Proposal for Supplement 1 to the 07 series of Amendments to Regulation No. 16 (Safety-belts)

Proposal of amendments to ECE/TRANS/WP.29/GRSP/2016/24

Figure 2

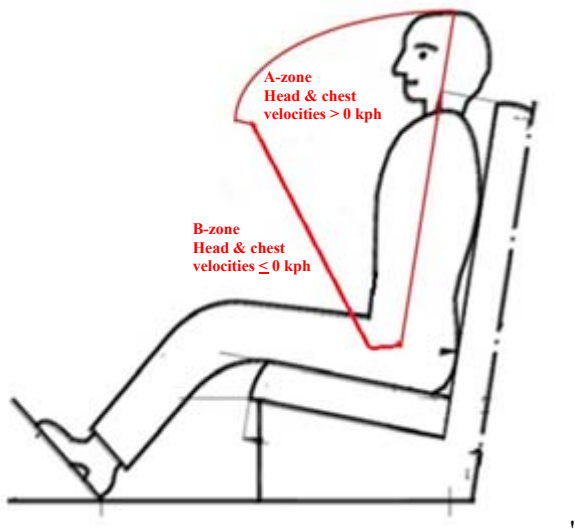
- "12.1. In case a restraint system has been granted/extended, those can be used for particular types of vehicles compatible with the following dimensional conditions: no interior part in a quoted A-zone as shown below (Figure 2):

Figures 1 to 3, amend to read:

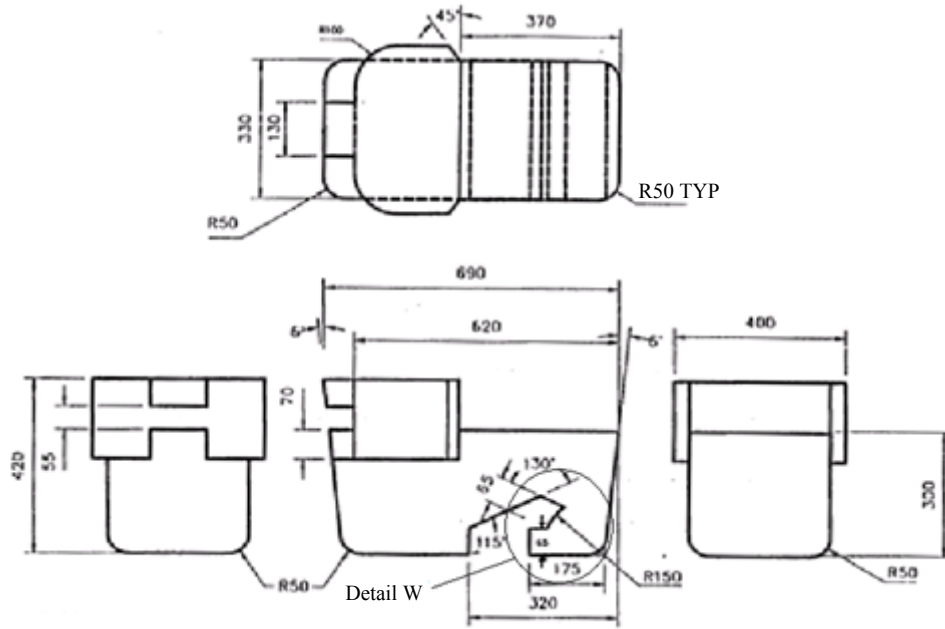
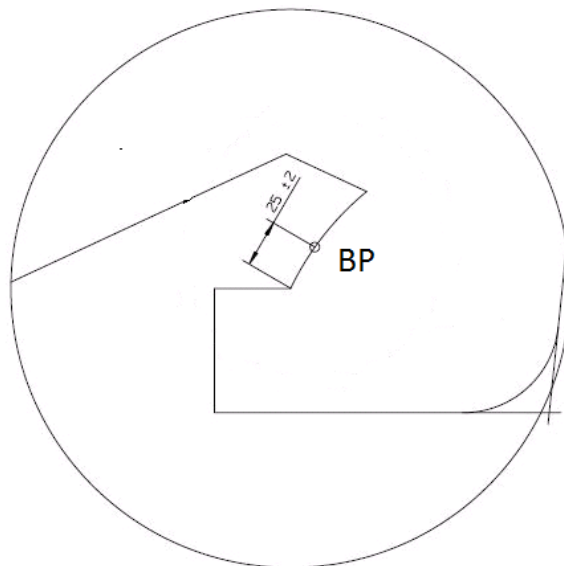
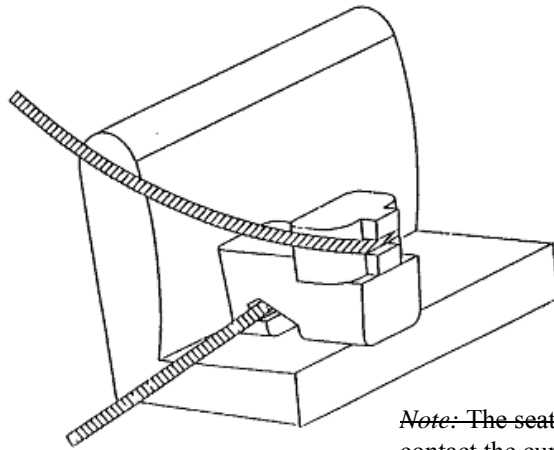
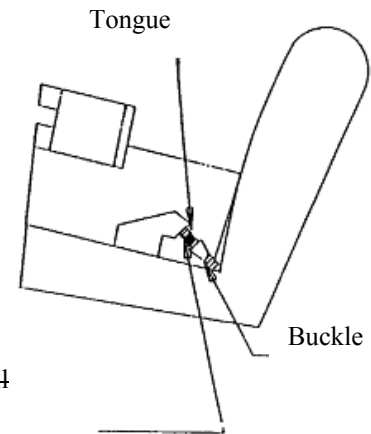
- "3.2. The lap portion of the belt shall touch the fixture on both sides at the rear of the lap belt path (see Figure 3). **The seat belt webbing shall always cover the points BP on the left and right ends of the curved edge; the exact position of point BP on the curved edge is indicated in detail W of Figure 1.**

Figure 7
Reduced-Size Rearward Facing toddler CRS Envelope dimensions for a reduced-size rearward-facing CRS, modified for improved compatibility with the vehicle interior

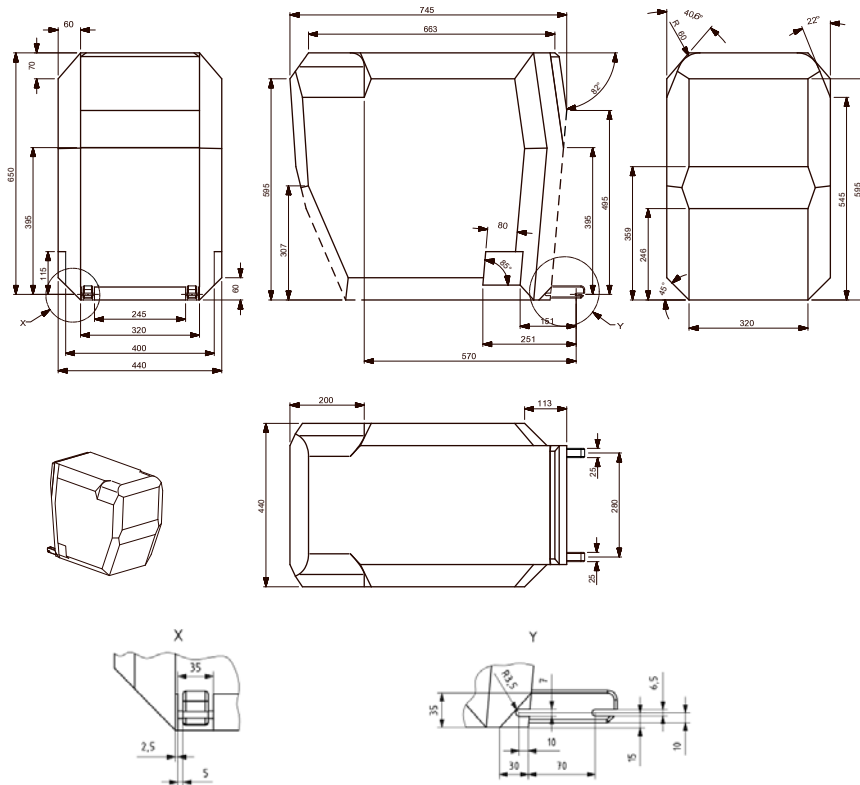
Annex 17, Appendix 2, insert new paragraph 4.7. and new Figure 7 to read:

"4.7. Rearward facing infant child restraint systems envelope ISO/R2X

Figure 1
Positioning in Seat

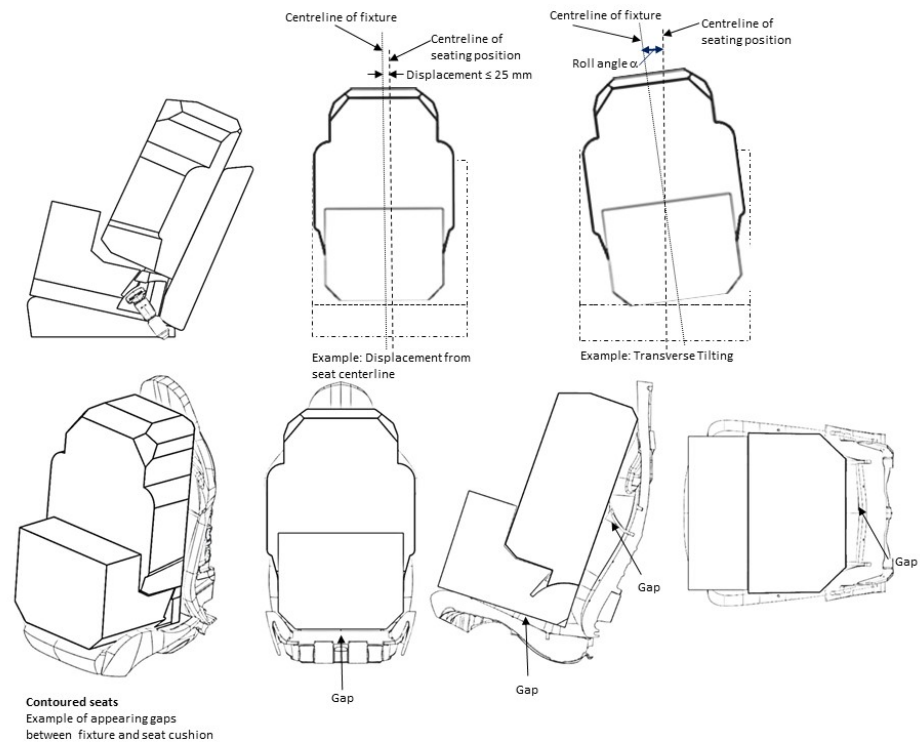
- 3.1. It shall be possible to secure the fixture in the seating position using the 3-point seat belt and to buckle up the seat belt.
- 3.2. The roll angle α as shown in Figure 1 shall be equal to or less than 5° .

- 3.3. The base of the fixture shall be in contact with the seat cushion, and the back face of the fixture shall be in contact with the seat back or head restraint. Full contact with the seat is not necessary, “gaps” due to the vehicle seats contours are permitted as shown by the arrows in Figure 1. The booster seat envelope is equipped with an adjustable backrest. Compatibility with the vehicle seating position shall be achieved in at least one position of the backrest range shown in Figure 2 or Figure 3.

Figure 2
ISO/B2: Envelope dimensions for booster seat, reduced width 440 mm - without ISOFIX, or with connectors removed or stowed within the body of the fixture (behind line E, as defined by detail B).

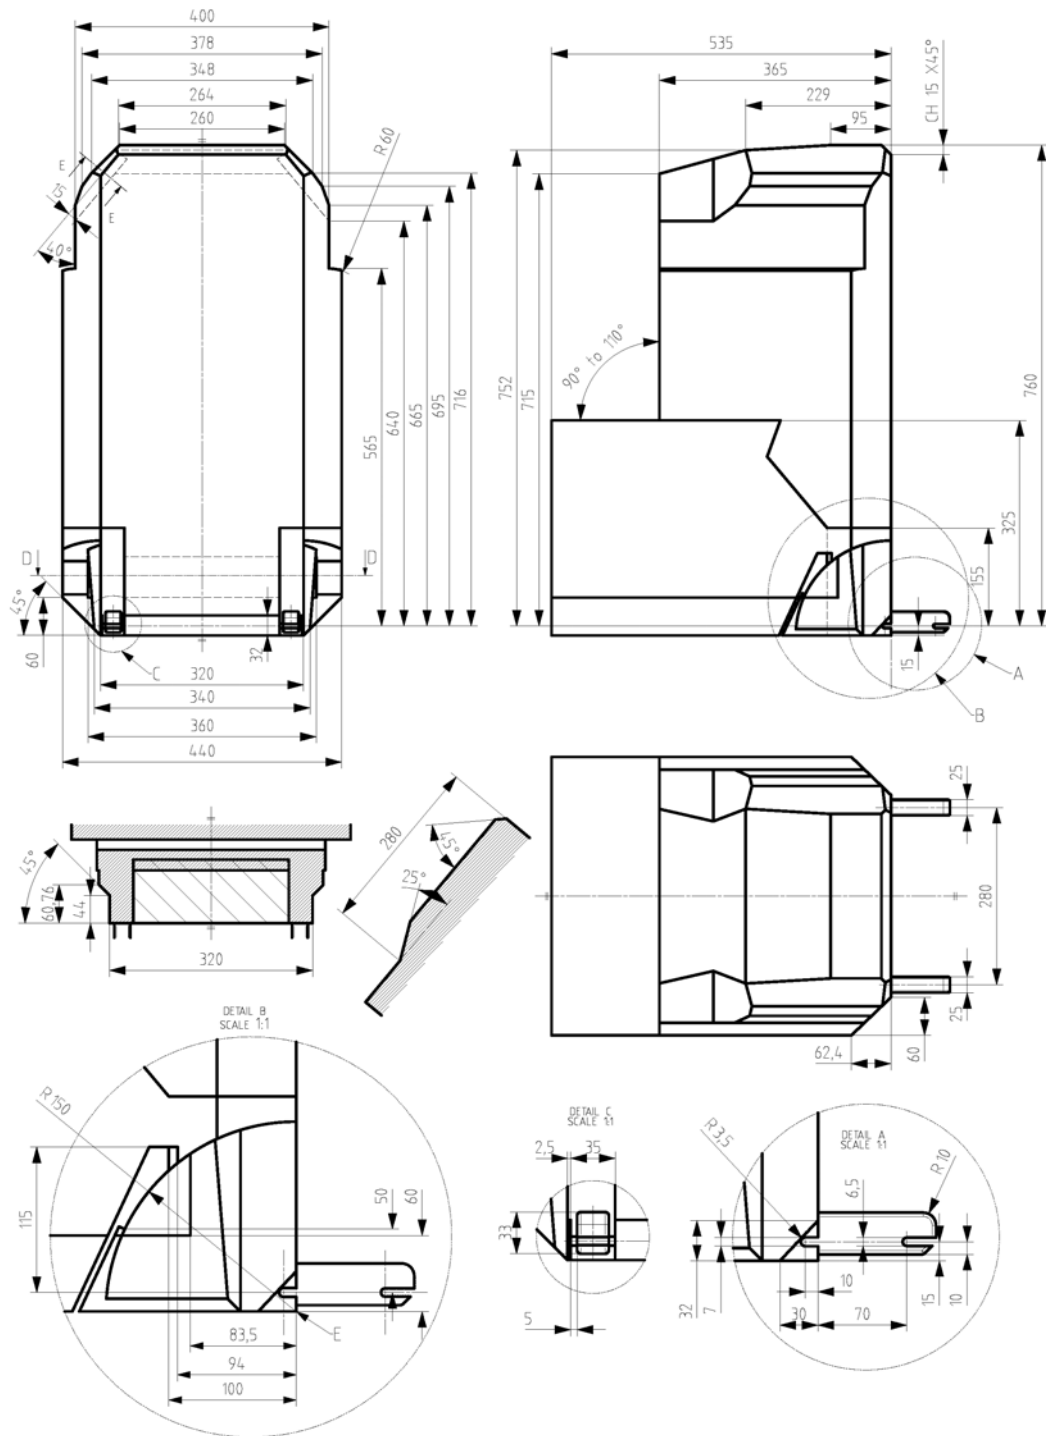
- ISO/B2: Booster seat, reduced width 440 mm (figure 2)
- ISO/B3: booster seat, full width 520 mm (figure 3)
